Networks NSW - Draft Determination Review

System Capex & Maintenance Prudency Assessment

Document No. 1 | Version No. 1

15 January 2015

Figure 3-1: Combined baseline capex forecast for the NSW DNSPs – strategic risk/expenditure profile highlighted at high-medium / 70-80% and implied risk / expenditure profile with expenditure reduced to \$5.5 b

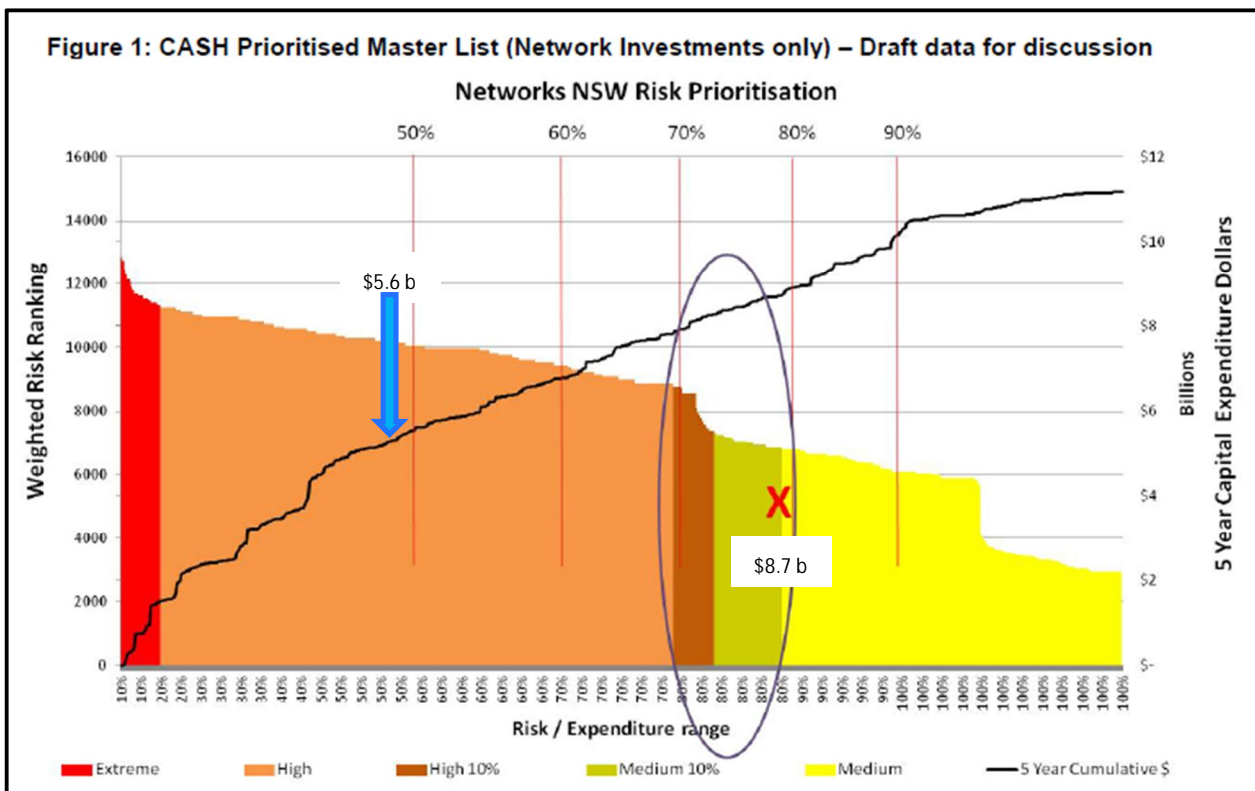
Also indicated in Figure 3-1 is the implied expenditure/risk profile with the combined capex forecast reduced to \$5.55 billion in accordance with the AER’s Draft Determinations. **Jacobs has not observed a robust discussion in Draft Determination documents that gives due consideration to this potential change to the combined risk profile of the NSW DNSPs should the indicated capex reductions be adopted.**

while maintaining a prudent overall risk profile through improving efficiencies. However, the figure below illustrates the magnitude of indicated reduction against the overall risk profile; and Jacobs considers it unlikely that it would be possible for the NSW DNSPs to absorb the indicated expenditure reductions purely through increased efficiency, especially given that the programs for the first year of the 2014-19 period are largely locked in.

Figure 3-9: FMECA/RCM output – Essential Energy Cross-arms

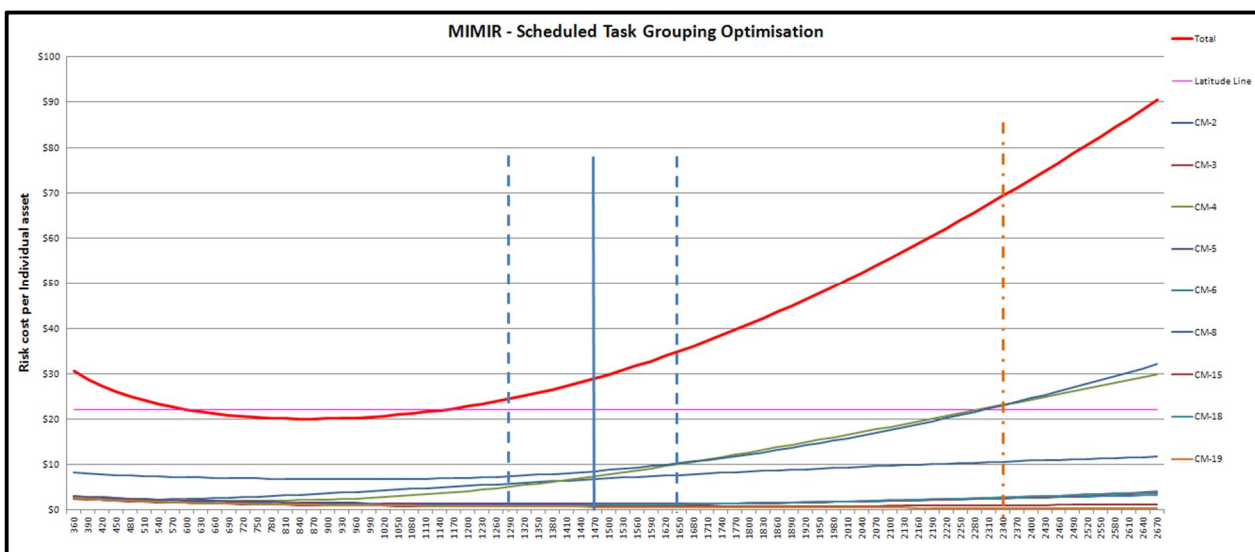
- The schedule delay, represented by the gap between the blue and orange vertical lines, will result in an approximate maintenance increase of 140% for the selected failure modes.

Figure 3-9 clearly demonstrates how the effects of reducing opex in the short term would result in significantly increased costs associated with managing the asset population over the long term.

Figure 4-1: Breakdown of capex at Risk by Primary Driver

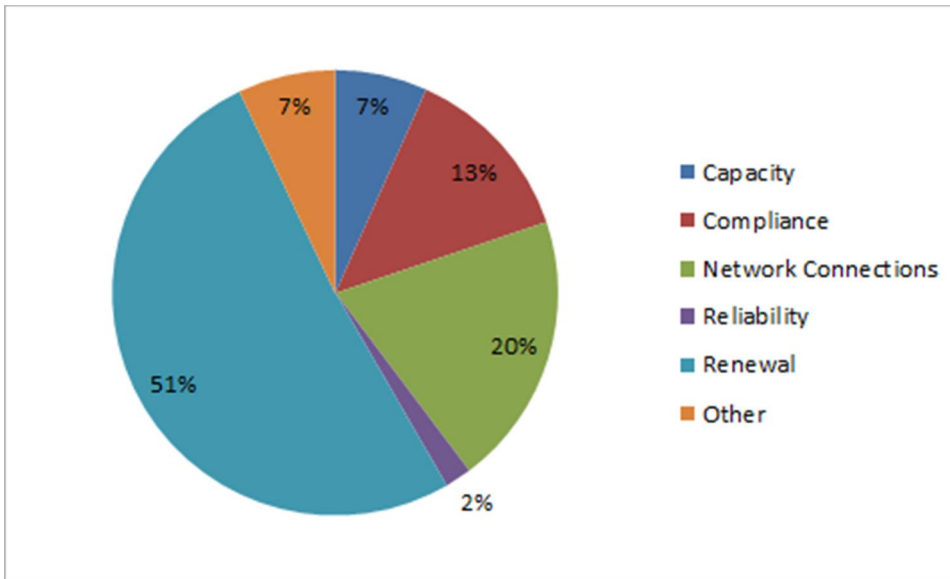
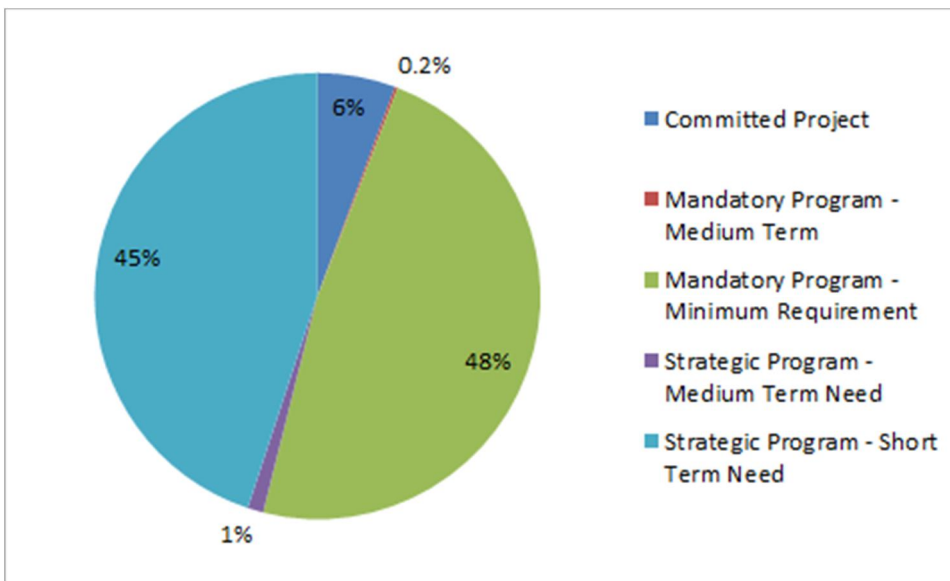
Figure 4-1 and Figure 4-2 below show a breakdown by primary driver and project category for the capex at risk (i.e. those falling below 73% of expenditure sorted based on highest CASH/PIP score). These charts illustrate the difficulty that the NSW DNSPs will have in managing the overall risks associated with providing essential electricity services if the capex reduction indicated in the Draft Determinations are imposed.

They show that the largest proportions of capex at risk are for asset renewals, mandatory programs to meet minimum regulatory requirements, and strategic projects to meet short term needs. This suggests that the networks are likely to:

- Have difficulty meeting their regulatory, customer and other stakeholder obligations.
- Begin showing signs of decreasing reliability and increasing risks to public safety within the 2014-19 regulatory period (as discussed in Section 3.3 with respect to when the impacts on network performance are likely to be evident from reduced opex, repex and augex).

Figure 4-3: Ausgrid Asset Age Profile

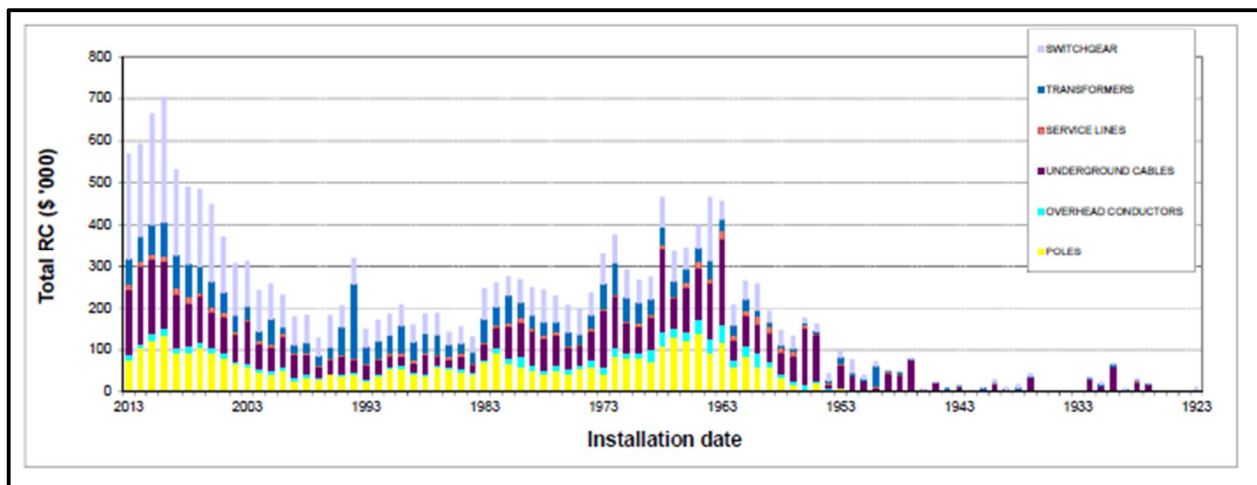
- Ausgrid's asset profile does not follow a normal distribution curve. This suggests that drawing conclusions based on average residual lives may be inappropriate.
- A large number of new assets were commissioned over the last decade. This would have increased the residual lives of the asset population as a whole. However, it does not indicate that the need to replace aging assets has been reduced; especially considering the augex investments over the past decade which are likely to have reduced the average age of the assets without necessarily replacing aging assets.
- There is a significant proportion of aging assets commissioned between 1950 and 1980 which are likely to be deteriorating and require replacement.

Jacobs notes that the Draft Determination makes the statement below. In Jacobs' view this highlights the AER's mistreatment of average residual asset lives, which are not viewed appropriately in conjunction with the age profiles. That is, regardless of the number of aging assets that have been replaced through recent augex, the reduction of the average asset age does not negate the need to replace the assets approaching the end of their serviceable life that were commissioned between 1950 and 1980.

Jacobs also notes that the AER has not included forward projections for the estimated residual lives of Ausgrid's assets as it has with the other NSW DNSPs. It is possible that if the forward projections were included they may highlight further anomalies with the AER's analysis and conclusions.

Figure 4-4: Endeavour Energy Asset Age Profile

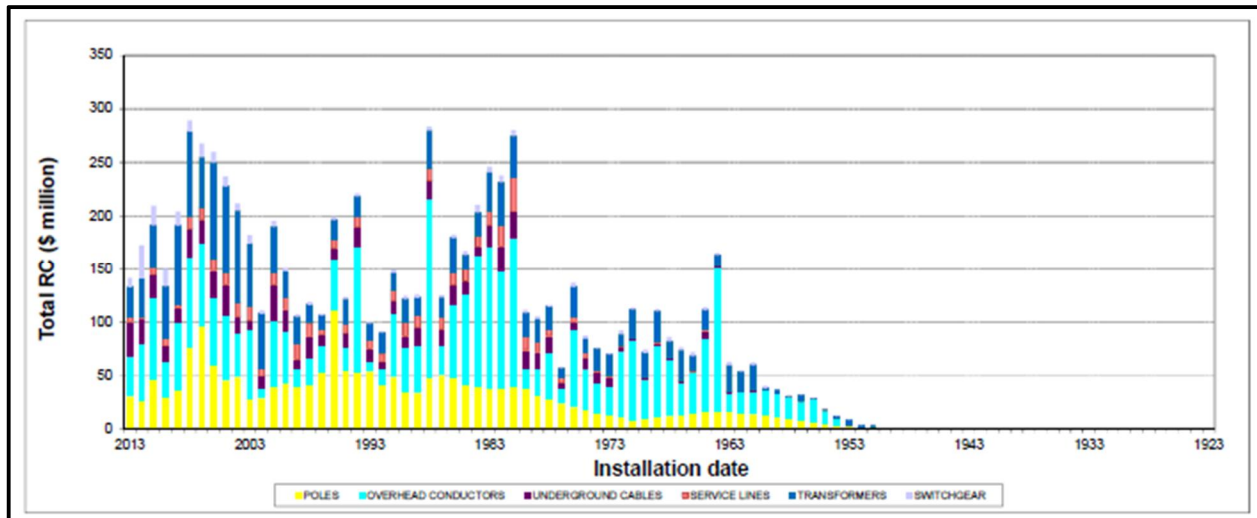
However, as per the discussion with respect to Ausgrid, this would not necessarily result in a steady repex requirement. The age profile of Endeavour Energy's asset population is shown in Figure 4-4 below. It shows that:

- Endeavour Energy's asset profile shows a skewed normal distribution curve, weighted toward relatively newer assets. This suggests that drawing conclusions based on average residual lives may be more reasonable than for Ausgrid.
- The majority of assets were commissioned between 1980 and the present. Although, this indicates that the majority of assets should be in reasonable health, it does not negate the need to replace aging assets.
- Endeavour Energy employ a Weighted Average Remaining Life (WARL) model to make long term forecasts remaining life, which are used in forming their repex programs.

Figure 4-5: Essential Energy Asset Age Profile

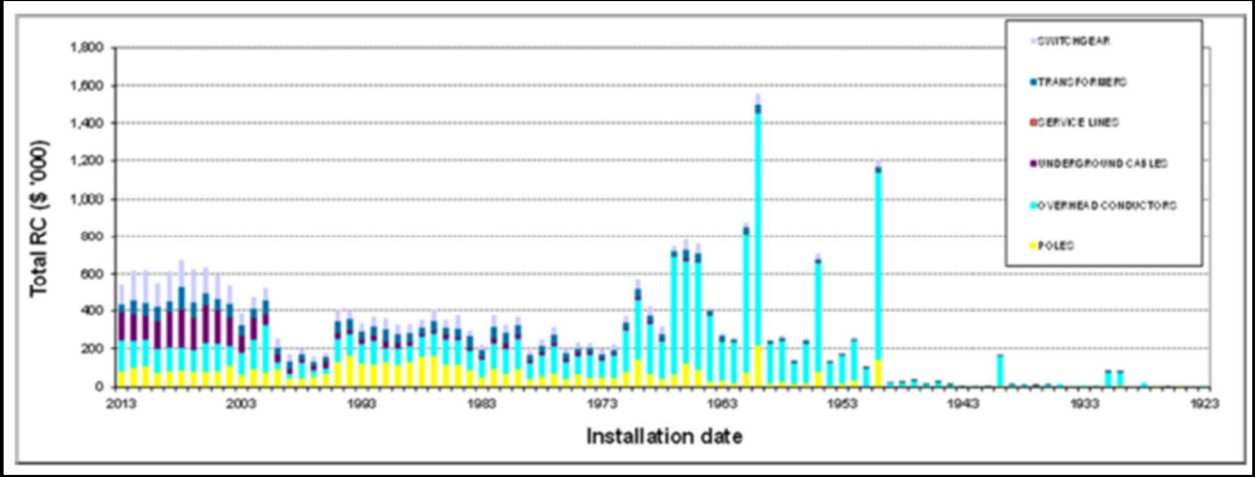
Notwithstanding, as per the discussion with respect to Ausgrid, this would not necessarily translate into repex requirements. The age profile of Essential Energy's asset population is shown in Figure 4-5 below. It shows Essential Energy's asset profile as relatively level, with a large number of aging assets commissioned between 1945 and 1970.

Given this age profile and the declining residual lives over the 2006 to 2013 period, it appears that it would not be unreasonable for some of the assets categories (especially the overhead network shown in light blue in Figure 4-5) to have their residual lives increased above 2006 levels.

Jacobs notes that underground assets above 33kV show a significant increase over 2006 levels. Jacobs expects that in its revised Expenditure Proposal Essential Energy would provide robust

justification that demonstrates the reasons for why the increased estimated residual lives for underground assets 33kV and above are warranted.
